***Interactive comment on “Linking baseflow separation and groundwater storage dynamics in an alpine basin (Dammagletscher, Switzerland)” by F. Kobierska et al.***

REVIEWER 1 – General comments

**Fig. 1.** Figure 4\_bis

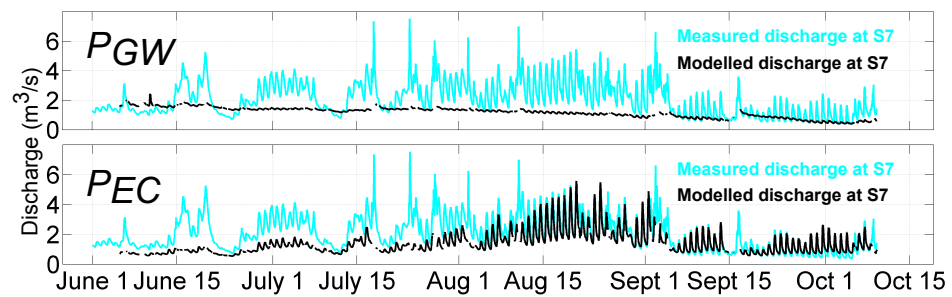
REVIEWER: Page 12202: It would be interesting to see a figure comparing the hydrographs of observed flows versus PEC and PGW.

AUTHORS: Please find attached the figure 4\_bis comparing PEC and PGW with measured discharge. We can see that PEC yields much better results than PGW. For now, we did not integrate those extra figures in the manuscript because we think that the performance values in Table 3 are sufficient and that the interested

reader can also access this response. Figure 4\_bis. Measured and modelled discharge (m<sup>3</sup>s<sup>-1</sup>) at S7 for the partial models PGW (upper panel) and PEC (lower panel).
